TE Connectivity

Product Change Notification: PCN-23-172909

XFP Cage Assembly

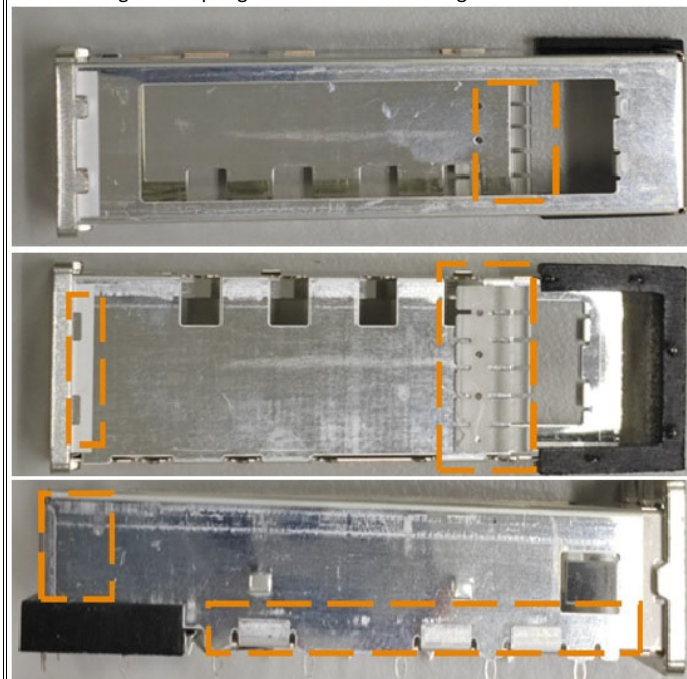
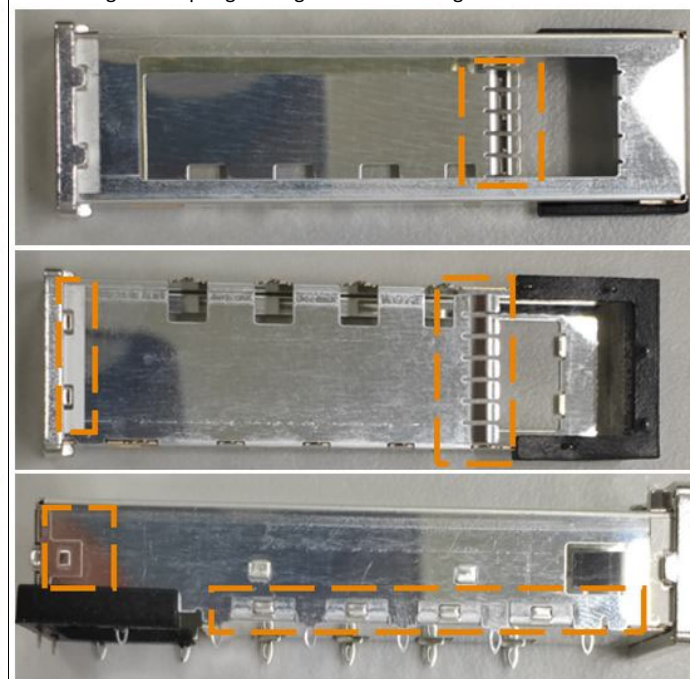
Please be aware of an upcoming feature change to the listed part numbers. Before Change: The intermediate EMI spring and the cage are two individual components and are assembled together to make the final cage assembly. After Change: The EMI Spring will be integrated into the cage design and would therefore become one single unit. Design Proposal Details have been attached along with the PCN. .

Before Change: EMI Spring is assembled on the cage

After Change: EMI Spring is integrated into the cage

To avoid the possibility that the spring may get peeled off from the cage after a long-time usage.
